CITY OF FRANKLIN  
PLAN COMMISSION MEETING\*  
FRANKLIN CITY HALL COUNCIL CHAMBERS  
9229 W. LOOMIS ROAD, FRANKLIN, WISCONSIN  
AGENDA  
THURSDAY, MAY 4, 2017, 7:00 P.M.

<b>Project Name:</b>	Interstate Partners Special Use and CSM
<b>Project Address:</b>	O West Oakwood Road (Tax Key No. 951-9994-001)
<b>Applicant:</b>	Caroline Brzezinski, Interstate Partners
<b>Property Owner(s):</b>	JAMS-4 LLC
<b>Current Zoning:</b>	Planned Development District No. 39
<b>2025 Future Land Use:</b>	Business Park
<b>Use of Surrounding Properties:</b>	Single-family residential and Wheaton Franciscan/Ascension Hospital to the north; trucking, areas of natural resource features, and single-family residential to the south; single-family residential and the City of Oak Creek to the east; and agricultural lands to the west
<b>Applicant Action Requested:</b>	Approval of the CSM and Special Use for two light industrial/light manufacturing mixed-use buildings

# PLAN COMMISSION DRAWINGS FOR: INTERSTATE PARTNERS SPECULATIVE INDUSTRIAL BUILDING

AS500

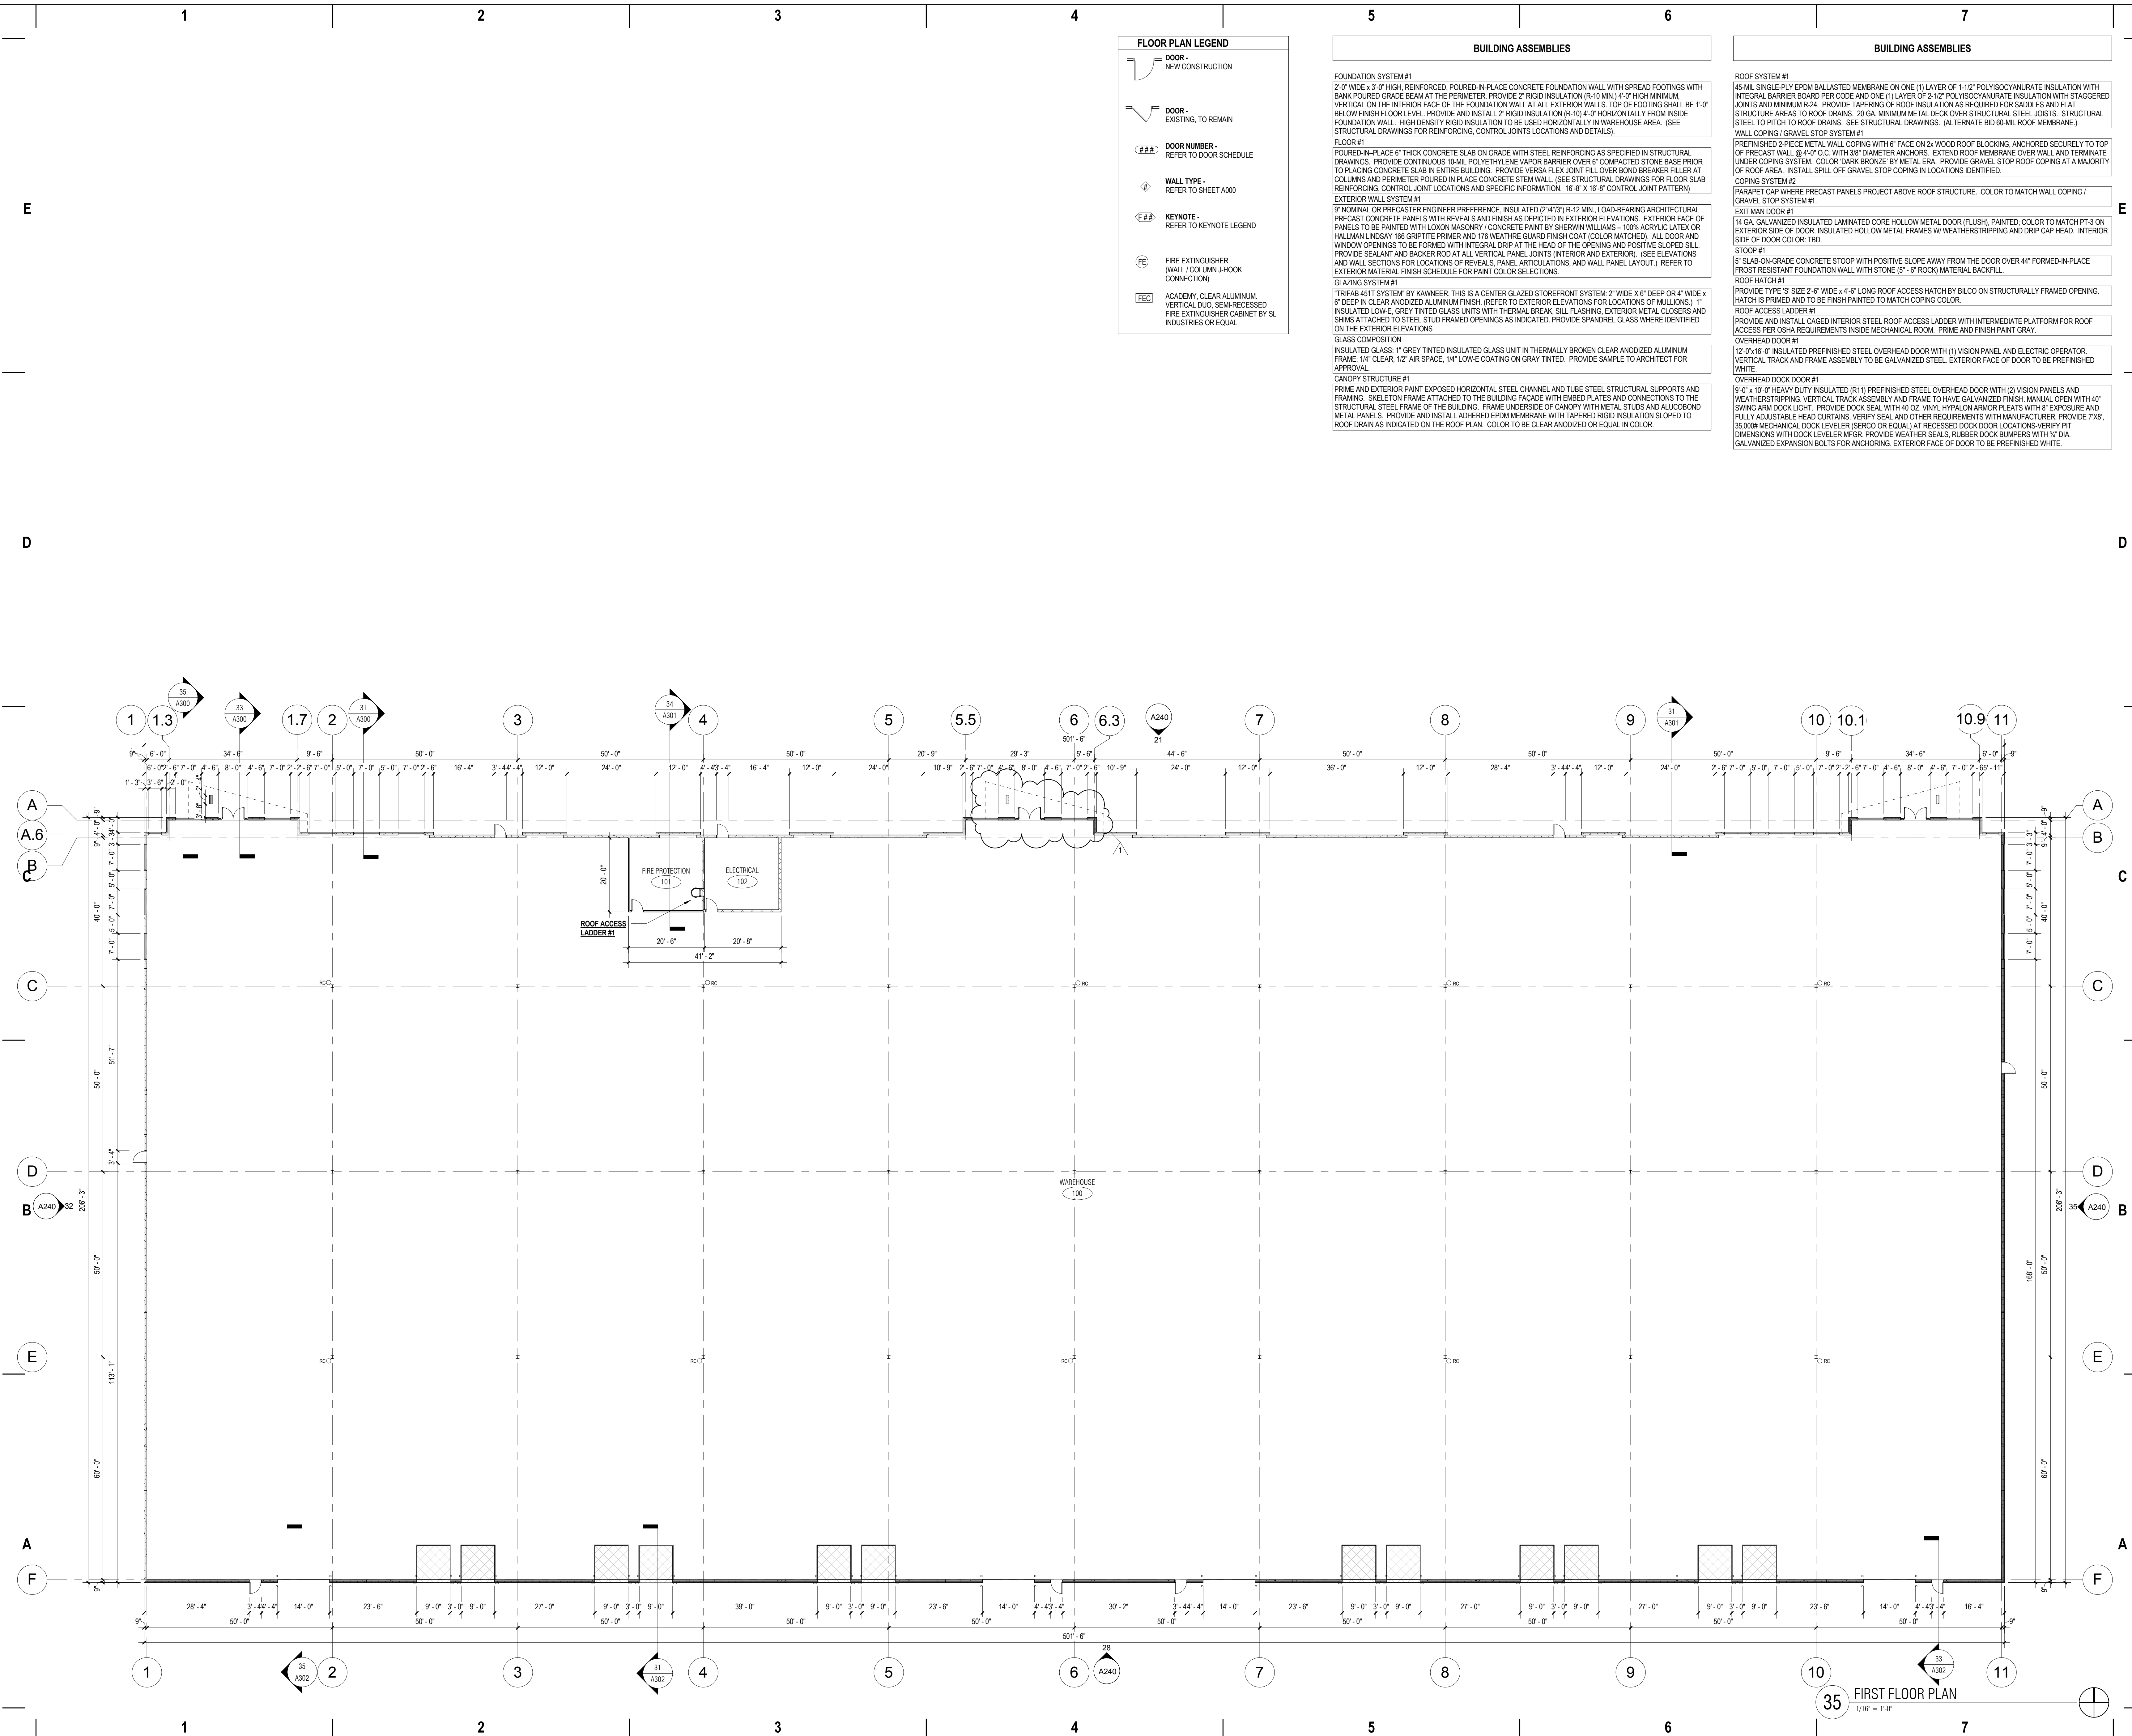
A dumpster enclosure is proposed and shown on the site plan. The enclosure will be constructed of painted CMU. Details can be found on Sheet AS500.

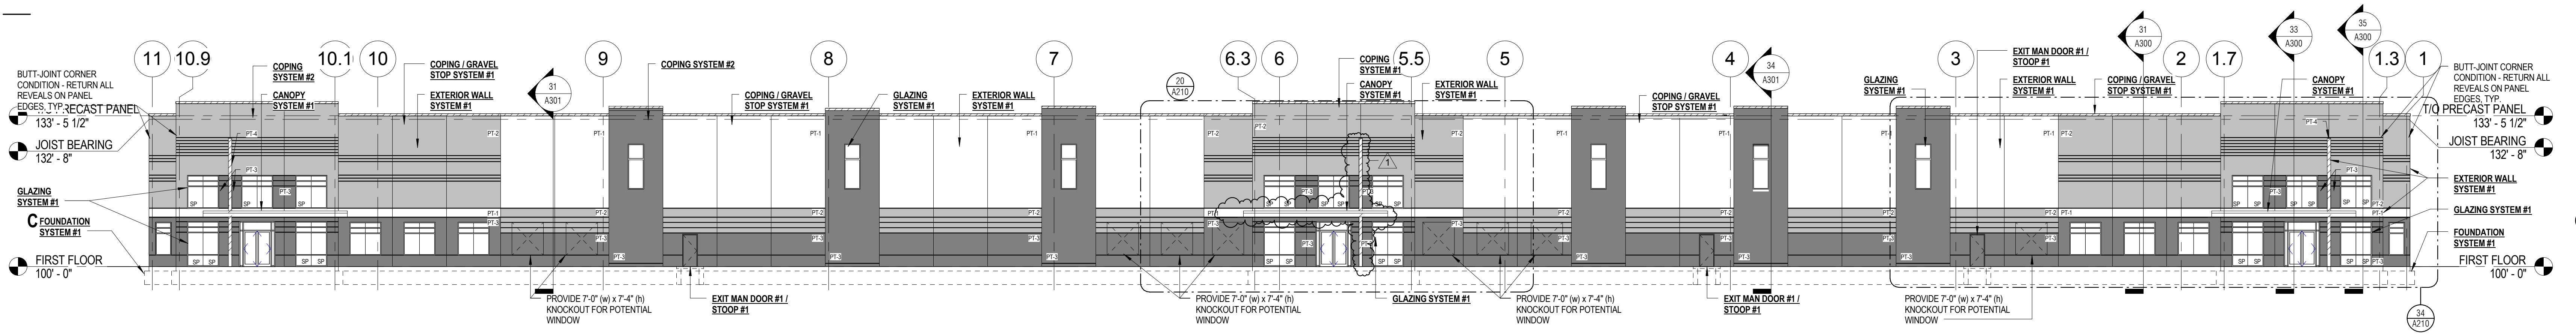
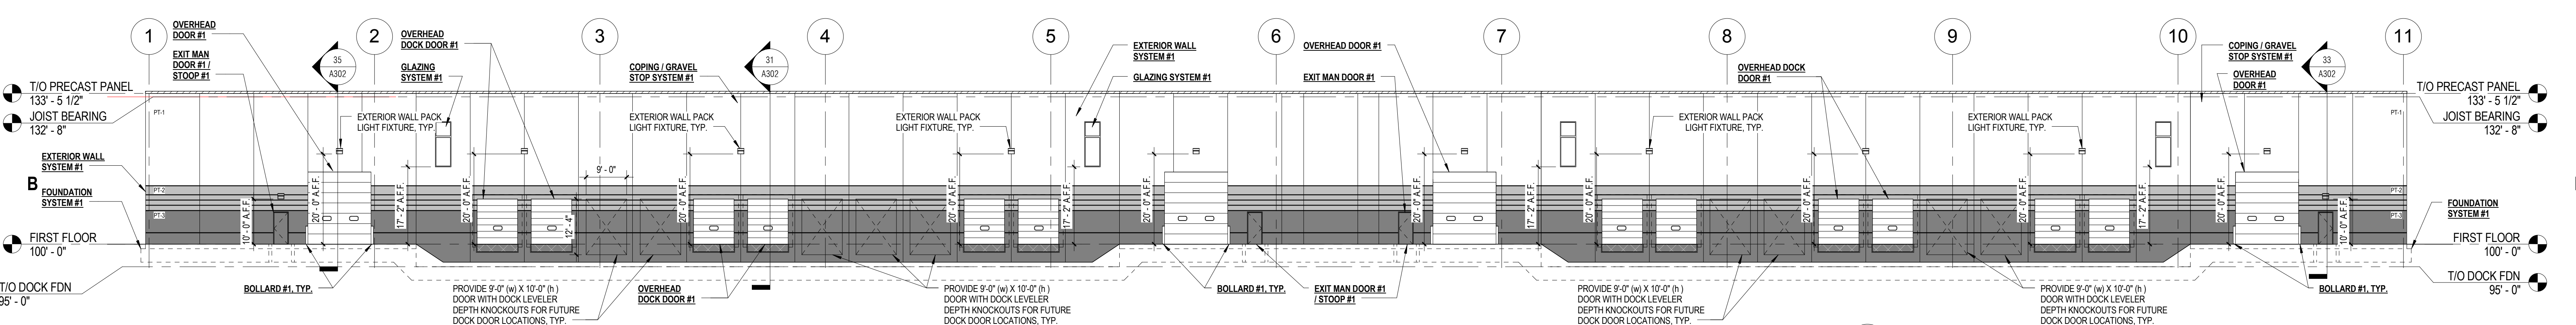
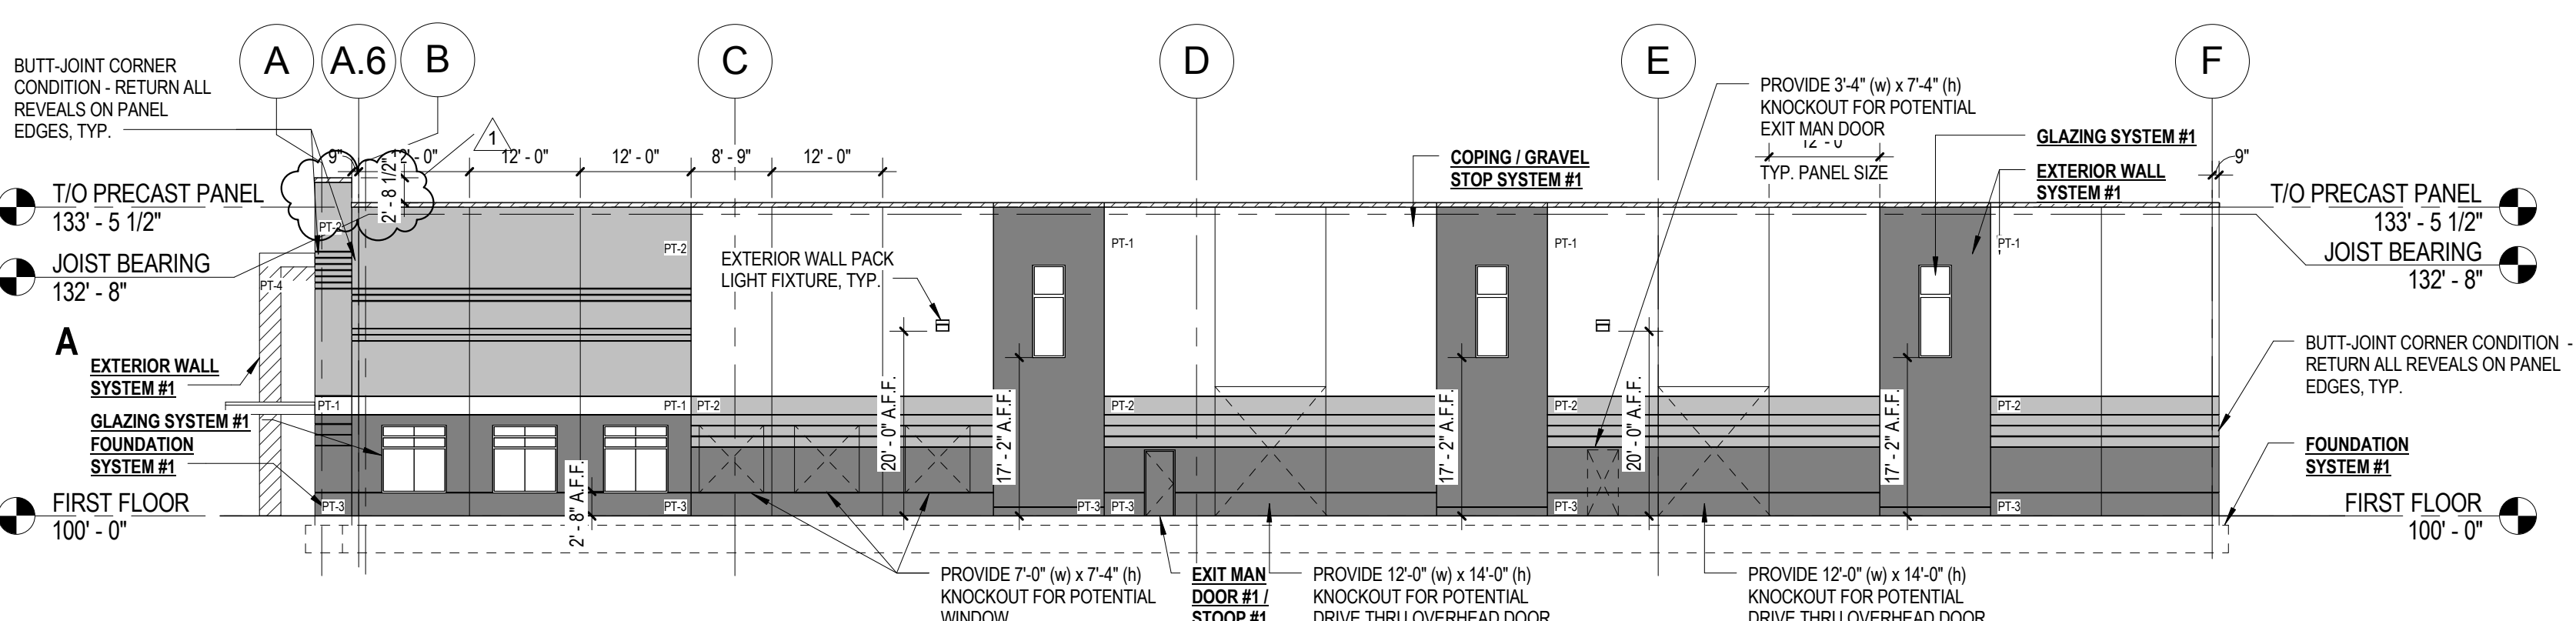
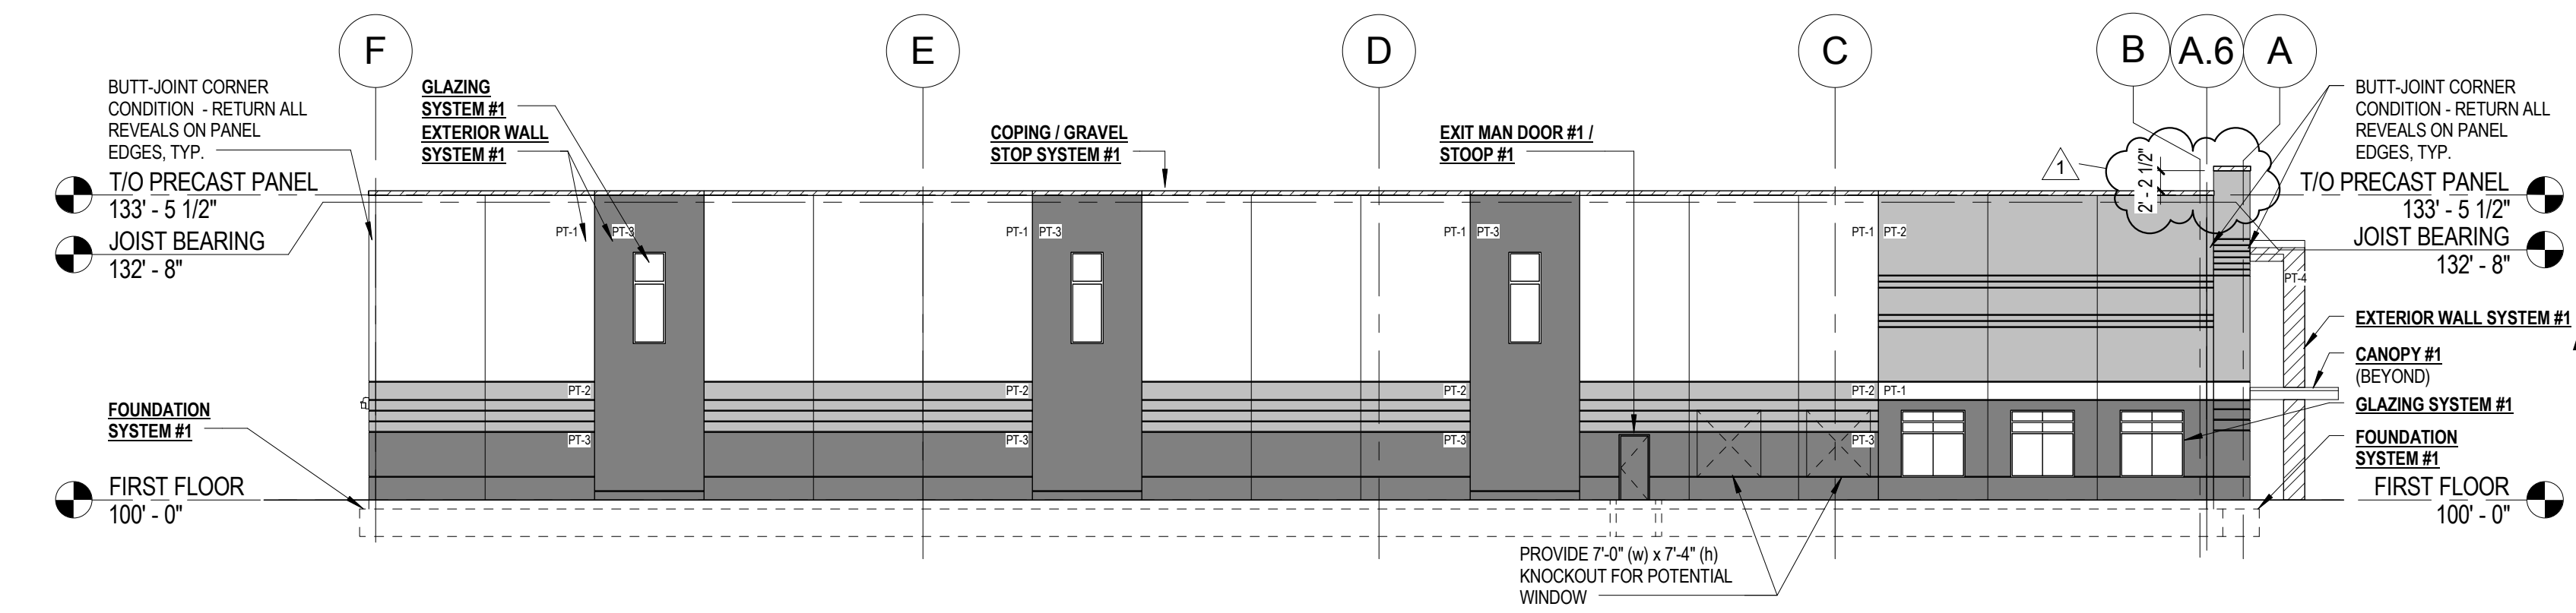
Staff suggests higher parapets for all or portions of the north, east, and west elevations of the building to provide more variation to the roofline and to help screen future rooftop mechanicals.
